20 March 2025

RE: Draft Amendment C244melt - Melton East PSP - Community Consultation

I represent Growland, a land developer with property holdings in Melton East (2 High Street and 592-610 Mount Cottrell Road), in response to the public consultation on the Melton East PSP led by the Victorian Planning Authority (VPA). We acknowledge the collaborative effort between the VPA, Melton City Council, State Government agencies, service authorities, and landowners in preparing this plan. Our comments focus on key aspects of the PSP, aiming to contribute to a more efficient and cost-effective outcome for the Melton East community.

Infrastructure and Development Staging

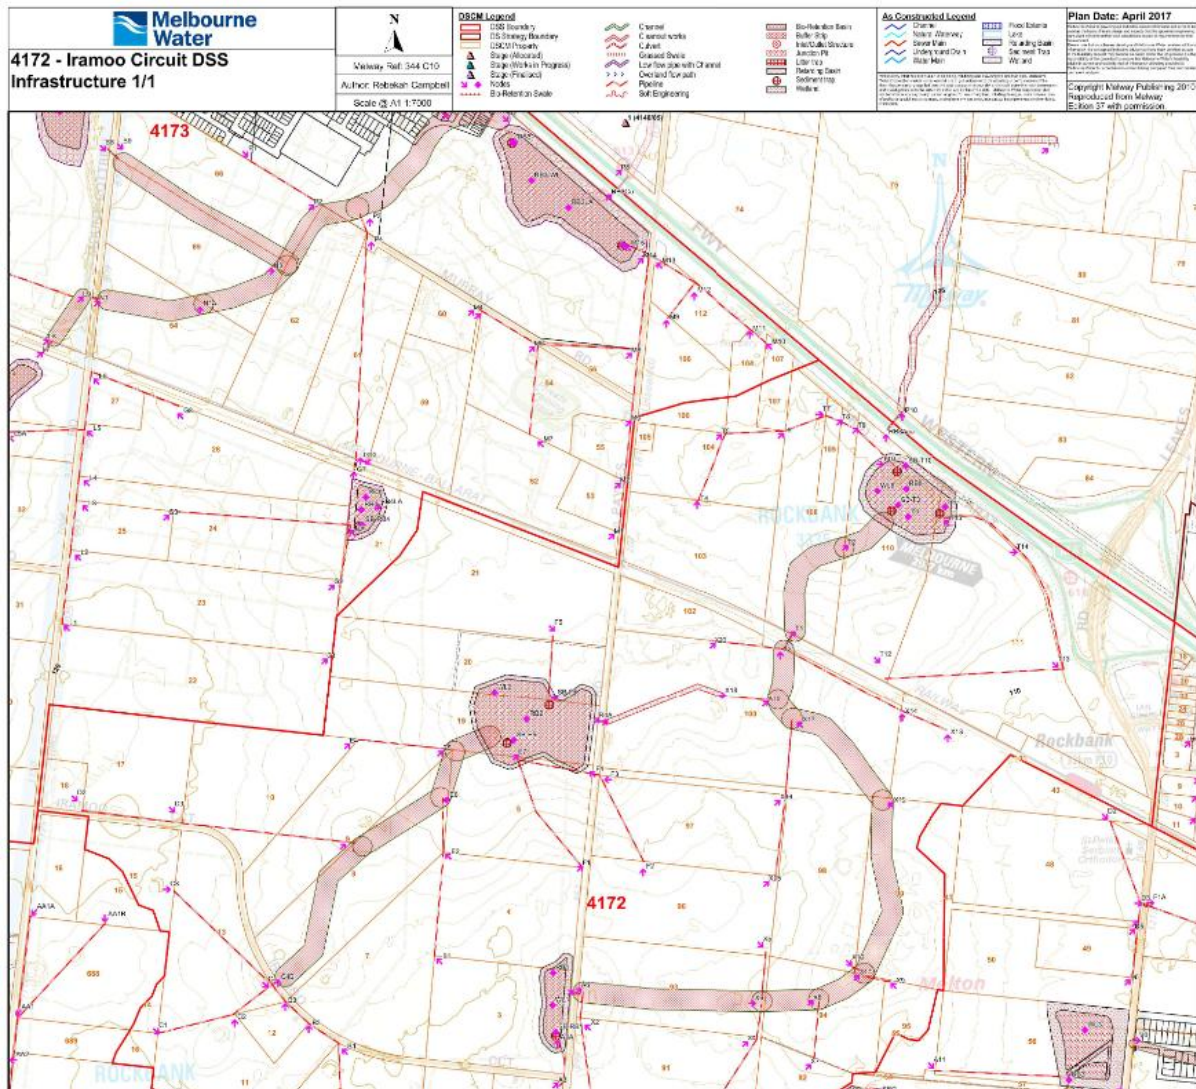
Reference - Melton East PSP – Infrastructure and Development Staging Plan Background Document

Staging as an issue

We have a fundamental problem with staging in PSP's as a philosophy. There are and will always be situations where land holdings in PSP areas are not owned by active developers. As a result, it is practically impossible to ensure that any particular phase of the PSP will be developed in an orderly manner. Therefore, all staging in PSP's should be removed.

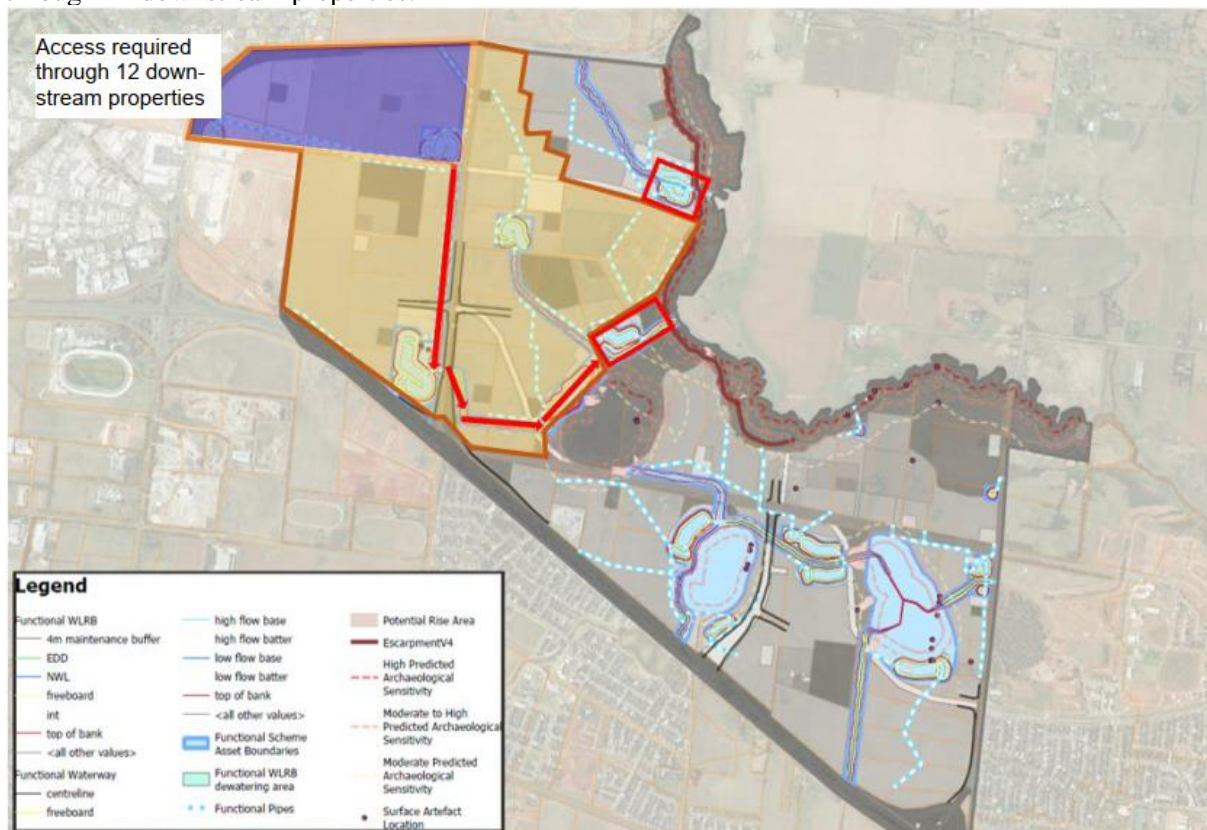
The property numbered '4' is identified as being in 'Stage 1' of the PSP due to proximity to services. While this property may have access to some services, including, most obviously, roads - it does not have access to sewer or drainage outfalls. In fact, access is required through no less than 15 downstream properties to achieve the ultimate drainage outfall. To obtain access agreements through 15 properties is a feat in itself. To make matters worse, however, 12 of these properties are identified in 'Stage 2' of the PSP. Why would a landowner in 'Stage 2' want to deliver infrastructure on their land? What is the benefit to them? These landowners will rightly feel unfairly treated by the PSP process, by being shunted into 'Stage 2', and will look to make up some of this loss by charging excessive license fees for upstream developers to obtain access, if they allow access at all. All of this adds cost and time to development, which is of course passed on to purchasers. Downstream landowners will also need to be incentivised to progress planning and engineering design on their sites to enable external works by others.

The document which identifies proposed staging is 'Melton East PSP Infrastructure and Development Staging Plan Background Document – March 2025'. This document drastically oversimplifies the importance of staging in relation to drainage. There is essentially only one sentence referring to drainage infrastructure in the report:

'Once the outfalls are built, the site risks will be reduced and the order of the preferred drainage development will then move up from the outfall.'

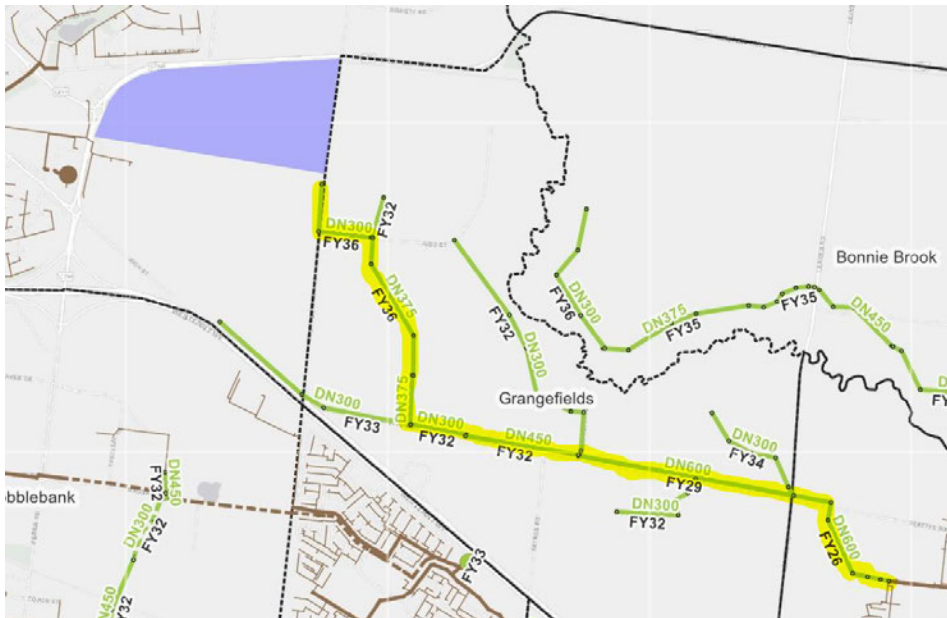
If only it were that easy. As stated earlier, there is a portion of proposed 'Stage 1' that requires access through 12 downstream properties:

Furthermore, this portion of proposed 'Stage 1' requires over 5km of downstream branch sewer with large associated bring forward costs that will negate reimbursements. The current planned alignment (highlighted below in yellow) includes delivery through a significant number of properties on the eastern side of Mt Cottrell Road to deliver the ultimate branch sewer outfall for the site.

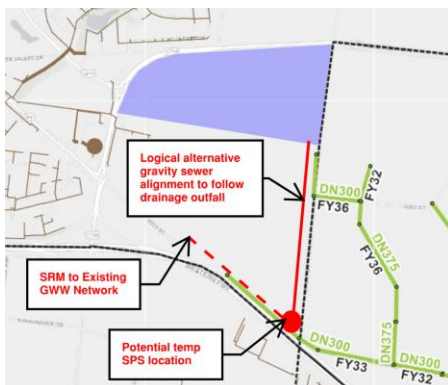
If the ultimate outfall is unfeasible to deliver with initial development due to cost, access or other planning issues, then there are opportunities to deliver interim sewer assets via temporary sewer pump stations and rising mains. However, these assets are expensive and are also not preferred for servicing as they impose additional maintenance regimes on the water authority. These temporary assets should therefore be located in sensible locations that will benefit as many committed developers and shovel ready sites as possible.

Greater Western Water would be willing to investigate reconfiguring and optimising the current planned sewer network should it be more efficient and economical. This would need to consider the various costs and timing impacts/opportunities between options given the more detailed aspects informing preferred planning solution. As an example, the below solution would service all Melton East PSP sites on the western side of Mt Cottrell Road, without reliance on any sewer works to the east of Mt Cottrell Road. Having the sites directly south of the purple area, sequenced to be delivered at the same time or earlier through PSP staging provisions, would allow this to happen.

Proposed alternative staging

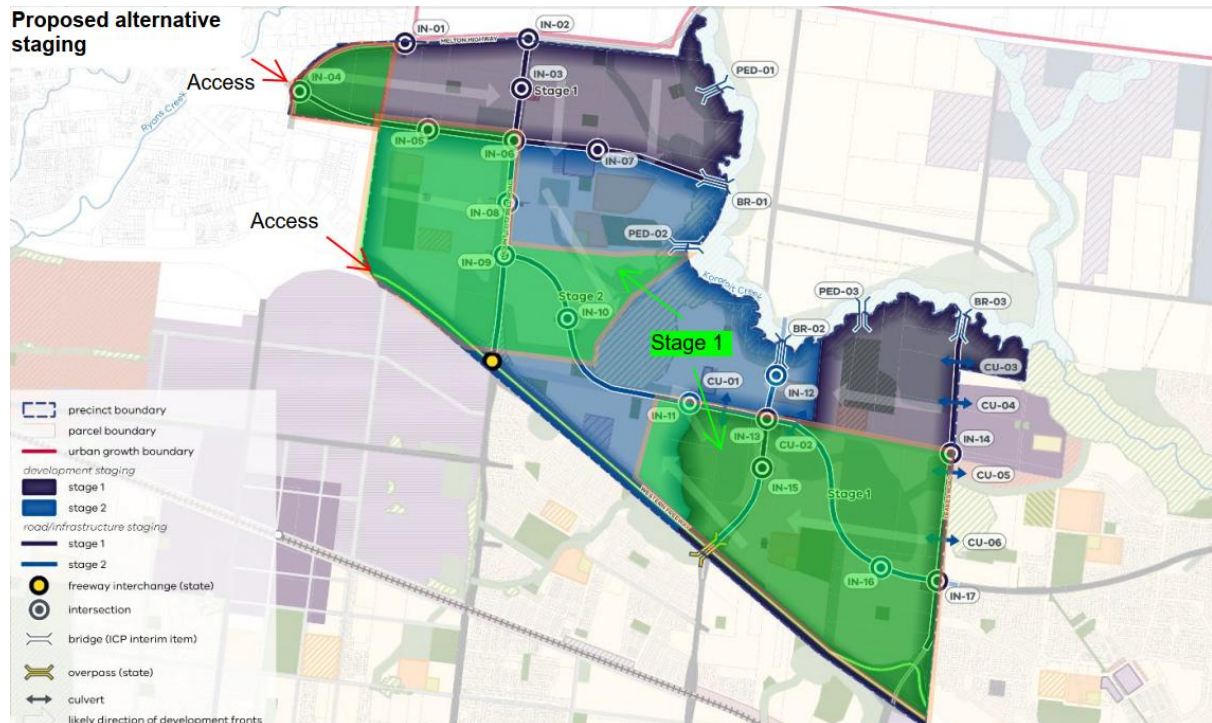
The below proposed staging considers the additional infrastructure which is available on the western boundary of the PSP. In the western portion of the PSP area, the Stage 1 land is also substantially closer to the drainage outfall.

A more appropriate way to determine stages in PSP's would be to give a different weighting to the importance of drainage infrastructure for the heat map analysis. This can be justified by the knowledge that all other services are ultimately easier to deliver, given access to build them is available through existing road reserves.

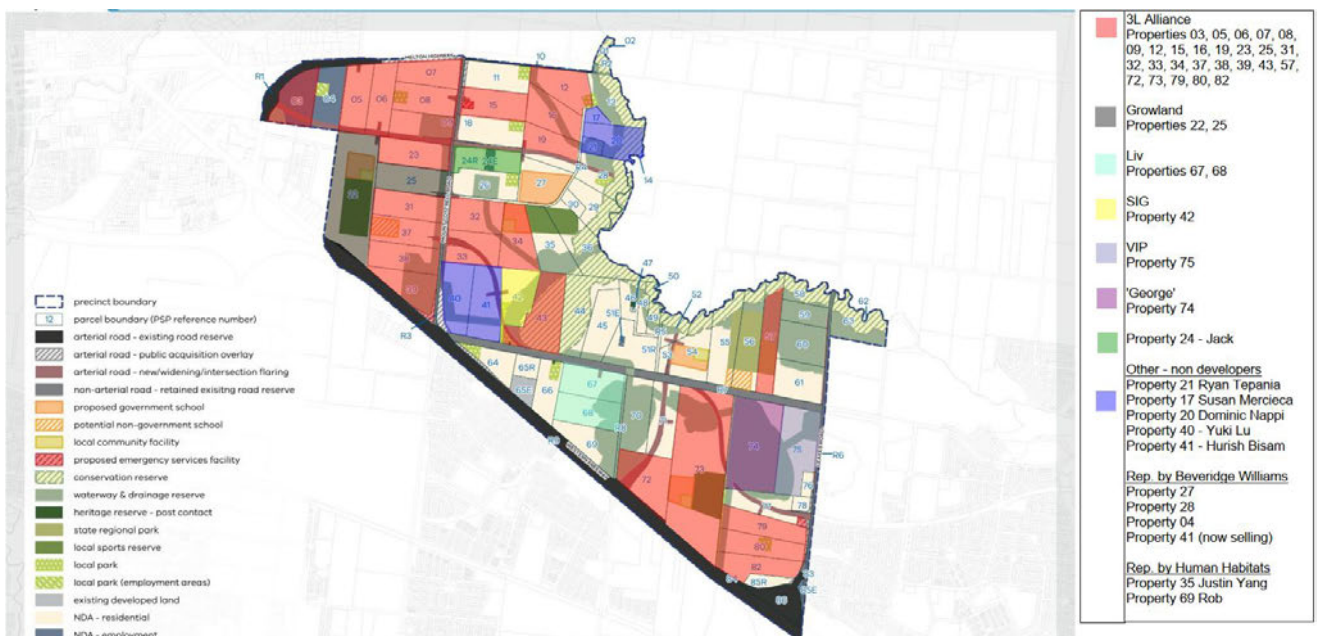
See below our preferred revised staging plan. This plan takes into all infrastructure:

- Drainage has the highest priority, all areas have easier or direct access to drainage outfalls, and;
- All other existing services are available adjacent to the stages – on the eastern and western boundaries.

The above staging would allow much more efficient and orderly development of the precinct.

This proposed staging also takes into account the majority land ownership by developers, who can better access the land collectively for servicing. If this staging is adopted, development will start immediately on both fronts, while if the current staging prevails, development will only commence in the eastern precinct. Note the proposed alternative staging also ensures there is a school and active open space in the western section of stage 1, this does not occur in the current plan.

Figure 13 – Sewer Servicing Options – Arcadis Mark-Up

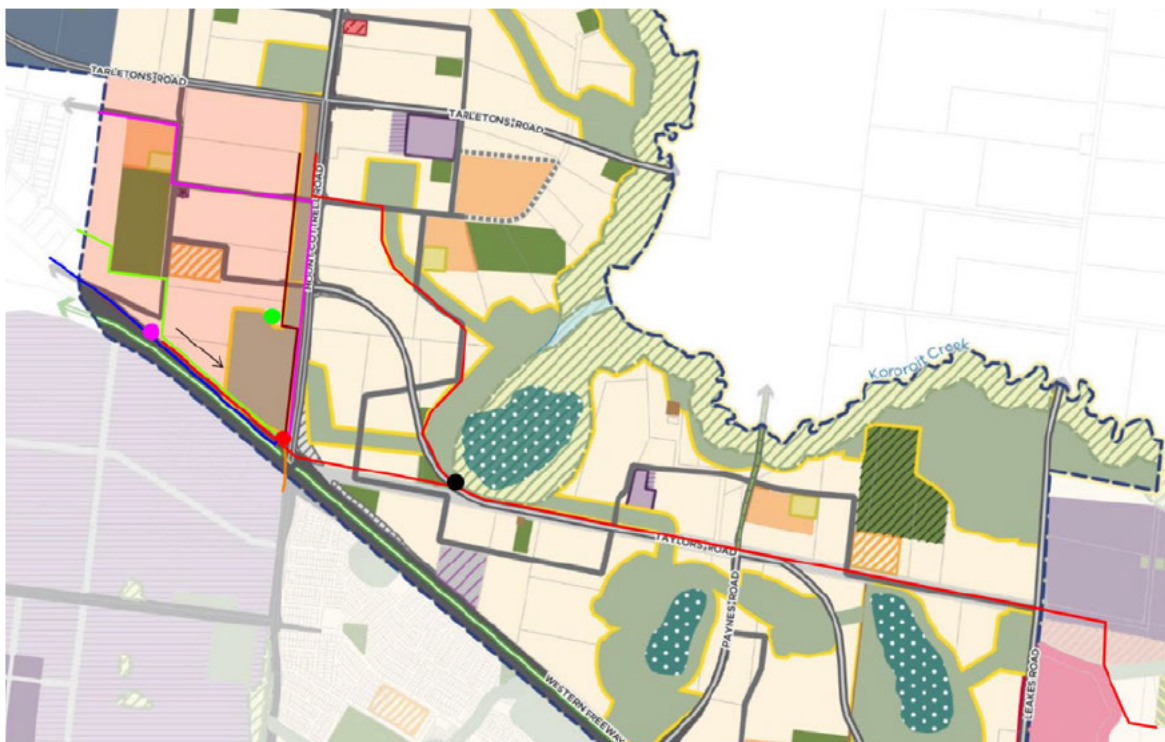
To enable a shared SPS for the 'red area', the following markup has been provided below in Figure 13 with the corresponding legend and comments.

Legend	Comments
Magenta Circle	Ideal temp SPS location if only servicing the subject site.
Black Circle	Ideal temp SPS location if PSP Property No. 23 and 25 need to outfall east even in interim. We note this is illogical due to waterway/drainage outfall and constrained due to the number of properties northern branch sewer alignment passes through. Extensive landowner consent agreements will be required to enable this outfall prior to delivery of those sites.
Red Circle	Ideal temp SPS location at mutual low point for all sites for 'red area', within 'read area'.
Green Circle	Potential alternative temp SPS location for all sites within 'red area'. Subject to further investigation with WLRB4 design and preliminary site grading noting this would require realignment of branch sewer currently proposed along southern boundary of WLRB4.
Red Lines	Future ultimate branch sewer as per Figure 12 above
Brown Line	Logical revised or temporary gravity sewer outfall for northern portion of 'red area' (i.e. property 23 and 25). Requires further discussion with GWW and other landowners.

Blue Line	GWW preferred SRM alignment along Western Freeway reserve to existing GWW sewer network in High Street. Existing GWW sewer network in High Street.
Green Line	Alternative SRM alignment through site owned by others and Subject Site – 2 High Street (note GWW prefer alignment in an existing road reserve)
Magenta Line	Alternative SRM alignment through Growland owned sites and road reserve.
Orange Line	Alternative SRM outfall to existing GWW sewer network on the southern side of freeway
